Subject: SDEIS Comments

Jenifer Young
SR520, I-5 to Medina: Bridge Replacement and HOV Project
Environmental Manager
SR520 Project Office
600 Stewart Street, Suite 520
Seattle, WA., 98101

The following are comments that we have regarding WSDOT's Supplemental Draft Environmental Impact Statement (SDEIS). Bill Mundy, as Chairman of the Canterbury Shores SR520 Committee, has also reviewed and commented on the SDEIS under a separate document. Our concerns parallel those found in the separate document in most instances. There are some exceptions, especially regarding health matters.

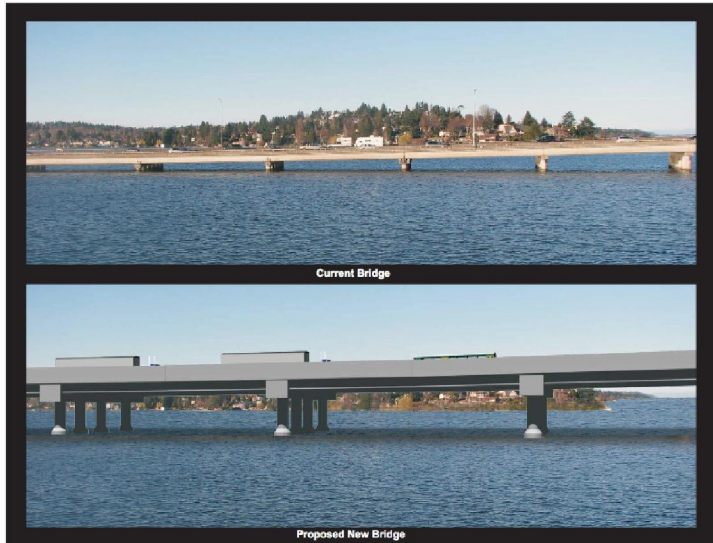
Exhibit 2-17 and 2-18 show existing and Option A (and the 2 other options also) views. Both exhibits are MISLEADING due to the INCORRECT way the photographs were taken (using an incorrect camera lens that does NOT show what the eye actually sees). Exhibit 2 shows what the view will actually be like from the north shore of NMP on a before and after basis. Exhibit 3 shows what the views will look like from the Madison Street pier, at the east end of Madison Street. These two exhibits were prepared by a professional photographer, Mr. Aaron Weholt, Legal Media, Seattle, WA.

C-045-015
Because there are more views in the project area than could be modeled, viewpoints are carefully selected to capture typical, representative views. Exhibit 2-17 of the Visual Quality and Aesthetics Discipline Report is representative of the views from the north shoreline of Madison Park. As can be seen in this exhibit, the view under the new bridge extends farther across the water than the view of the existing

It is an accepted industry standard to use the focal length used for these images (roughly 35 mm depending on the camera) because the view is wide but without distortion at the outer edges. The SDEIS visualizations were created by graphics artists who specialize in creating 3-D models based on engineering designs and placing the 3-D models in photographs.
